ADDENDUM #2

Project Name: **Lake Woodard Annex Renovations**
Owner: Raleigh Water
City Bid #: MISC-2020-46R
HH Project #: 16-097
From: **HH Architecture**
David Carey, Associate AIA, LEED AP dcarey@hh-arch.com
To: All plan holders

1 2nd FLOOR PLAN REVISIONS
SK01 1/8" = 1'-0"

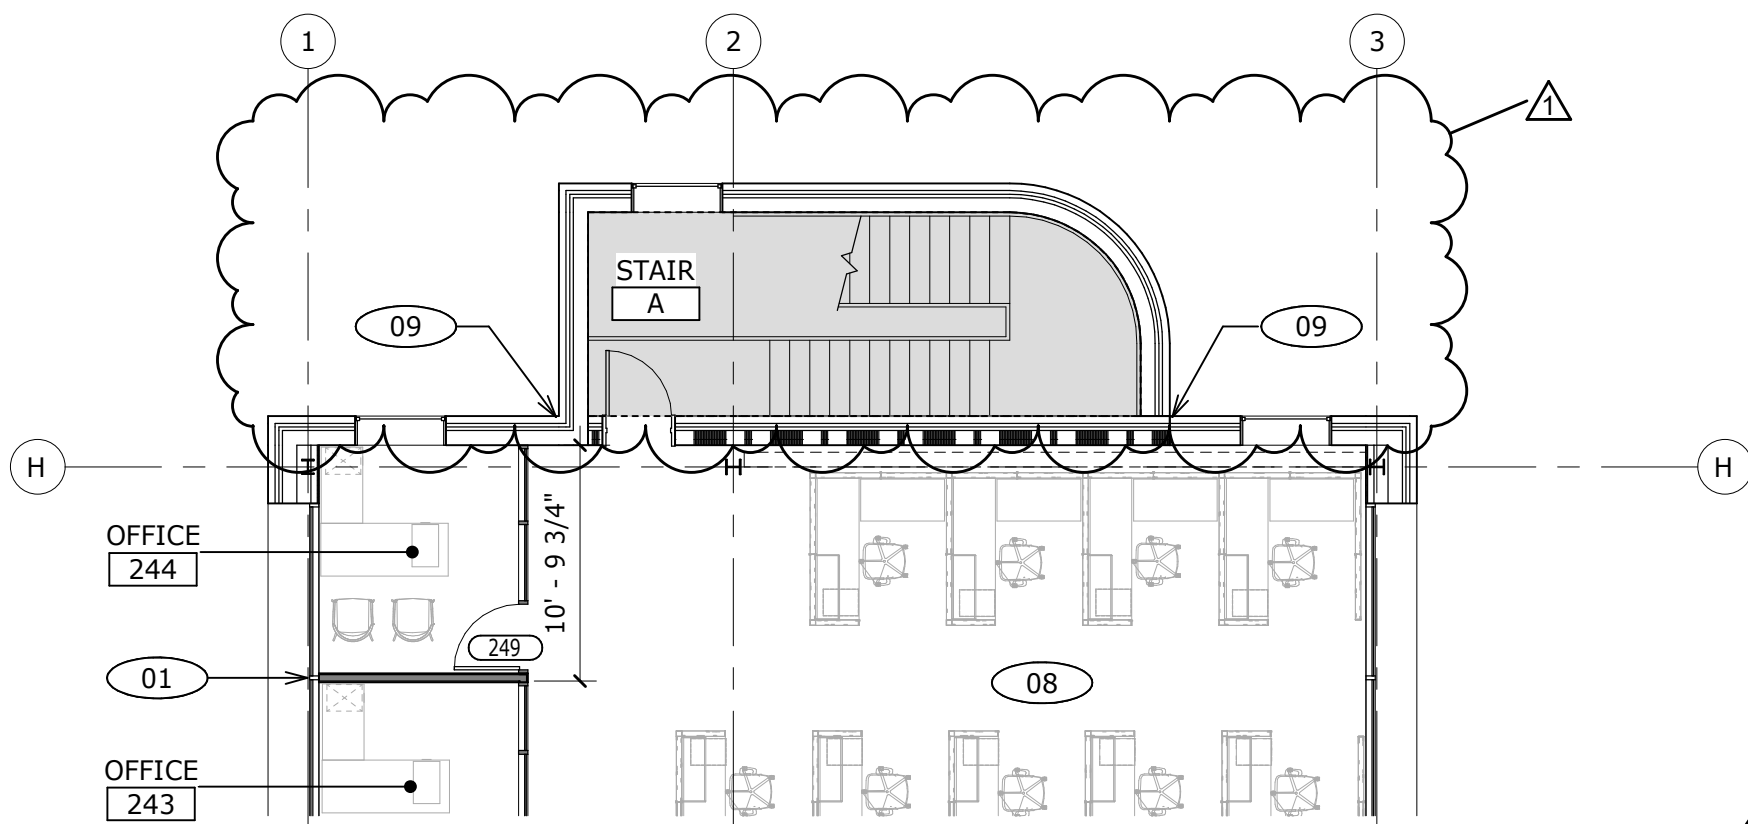
1. Sheet G000:
 - a. **Delete** reference to "known presence of asbestos" and "lead-based paint warning" under Warnings & Notes section. It is not expected that hazardous materials are present in the building. Reference Selective Demolition specification 024119, section 1.8 – D.
2. Sheet A121: **ADD** attached bulletin SK01 referencing building joint sealant.

- 07 PAINT ALL NEW MECHANICAL DUCKWORK/CONDUIT TO MATCH EXISTING. PAINTING OF DECK IS NOT REQUIRED.
- 08 ALL FURNITURE BY OWNER
- 09 CONTRACTOR TO REPLACE VERTICAL CONTROL JOINT SEALANT BETWEEN STAIR SHAFT AND MAIN BUILDING STRUCTURE UPON COMPLETION OF HELICAL PIER REPAIR WORK. ASSUME BUILDING HEIGHT OF 35-FEET.
